# Master Sign Plan

## 15-090MSP – BSD Scioto River Neighborhood District

### Big Sandy Superstore – Dublin Village Center 6825 Dublin Center Drive

Main Entrance Detail

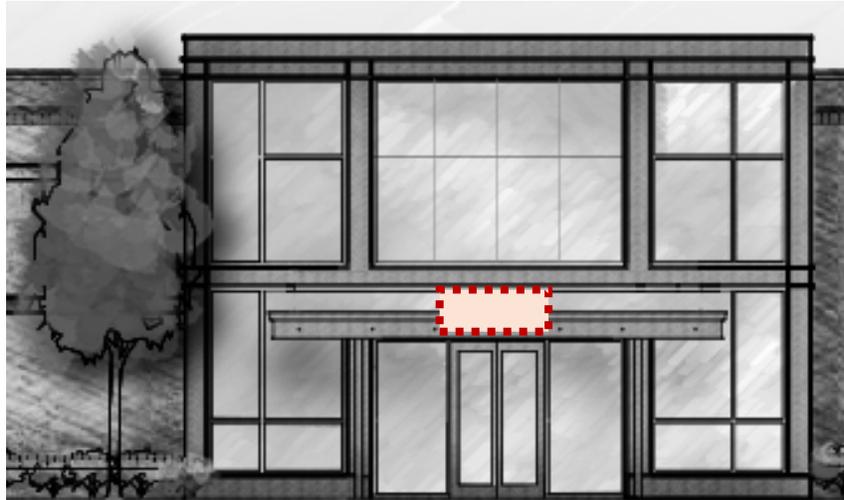
The proposed primary entry sign is 471.75 sq. ft. in size. The “Big Sandy” text is channel letters in the style of the Big Sandy trademark and is integrated into the main entry glass and steel curtain wall system. The “superstore” script sign, also part of the Big Sandy trademark, and is mounted to the entry canopy. Code allows 1/2 sq. ft. of sign for each lineal foot of building wall up to a maximum size of 50 sq. ft. The center section of the building façade could be calculated at 160 lineal feet, which results in an 80 sq. ft. sign. The applicant stated that the sign was sized to be proportional to the scale of the entry. The entry atrium is 3,760 sq. ft. The sign area is 15% of the atrium entry area.

The applicant has made a request to allow two additional wall signs over the two new secondary entries.
